T10/04-195r0 SAS-1.1 Internal Wide Connector/Cable Electrical Requirements

To: T10 Technical Committee
 From: Barry Olawsky, HP (barry.olawsky@hp.com)
 Date: 1 July 2004
 Subject: T10/04-195r0 SAS-1.1 Internal Wide Connector/Cable Electrical Requirements

Table — Internal 4-lane Cable/Connector Solution Electrical Requirements

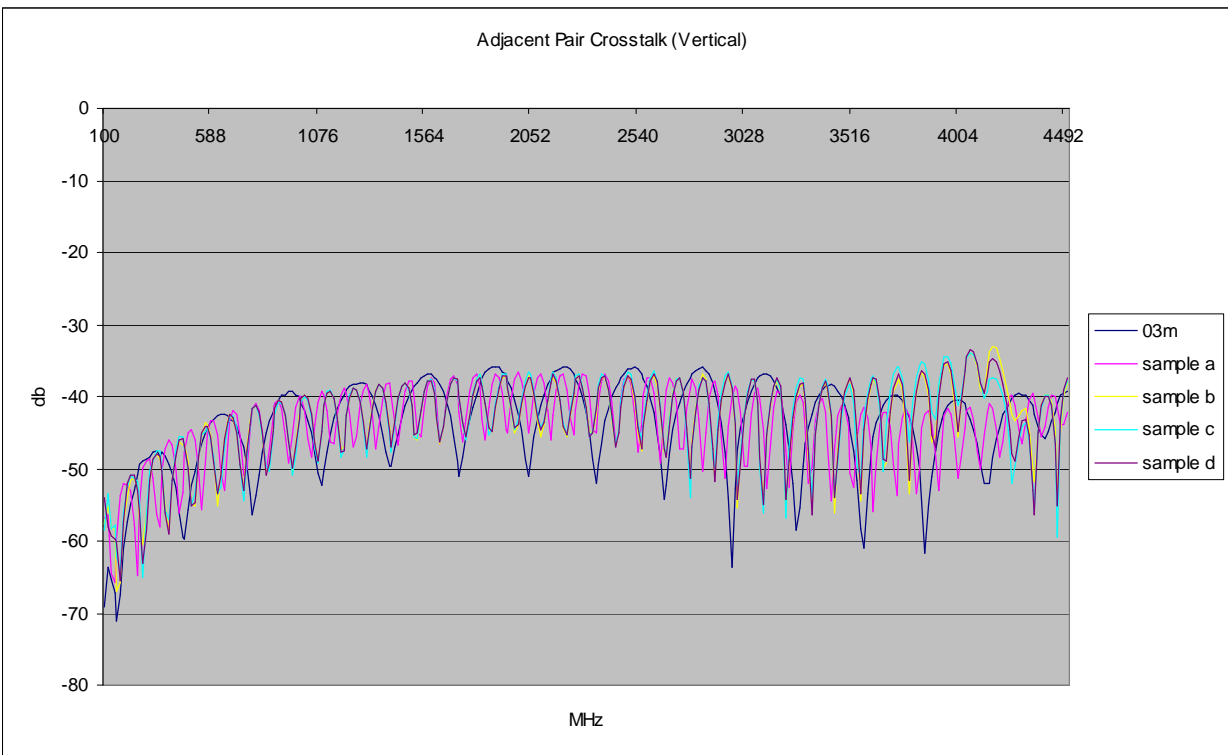
Add the following table to section after impedance requirements table.

Requirement	Units	1,5 Gbps	3,0 Gbps
Time domain reflectometer rise time 20 % to 80 % ^{a, b}	ps	70	70
Media (PCB or cable)			
Differential impedance ^{b, c, d}	ohm	100 ± 10	100 ± 10
Differential impedance imbalance ^{b, c, d, e}	ohm	5	5
Common mode impedance ^{b, c, d}	ohm	32,5 ± 7,5	32,5 ± 7,5
Mated connectors			
Differential impedance ^{b, c, d}	ohm	100 ± 15	100 ± 15
Mated Cable Assembly			
Maximum Insertion Loss ^{b, f}	db	6	6
Maximum Near-End Crosstalk (adjacent pairs) ^{b, f, g}	db	33	33
Maximum Near-End Crosstalk (between pairs differential signal pairs 1, 2, 3 and 4) ^{b, f, g}	db	45	45
Maximum Near-End Crosstalk (between differential signal pairs 5, 6, 7 and 8) ^{b, f, g}	db	45	45
Maximum Near-End Crosstalk (all other differential signal pair combinations) ^{b, f, g}	db	50	50
Maximum Intra-Pair Skew ^b	ps	10	10
<p>^a All times indicated for time domain reflectometer measurements are recorded times. Recorded times are twice the transit time of the time domain reflectometer signal.</p> <p>^b All measurements are made through mated connector pairs.</p> <p>^c The media impedance measurement identifies the impedance mismatches present in the media when terminated in its characteristic impedance. This measurement excludes mated connectors at both ends of the media, when present, but includes any intermediate connectors or splices. The mated connectors measurement applies only to the mated connector pair at each end, as applicable.</p> <p>^d Where the media has an electrical length of > 4 ns the procedure detailed in SFF-8410, or an</p>

equivalent procedure, shall be used to determine the impedance.

- e The difference in measured impedance to ground on the plus and minus terminals on the interconnect, transmitter or receiver, with a differential test signal applied to those terminals.
- f The range for this frequency domain measurement is 10 to 4500 MHz.
- g The far end of the mated cable assembly must be properly terminated. Insertion loss variations (i.e. cable length) may change the measurement result.
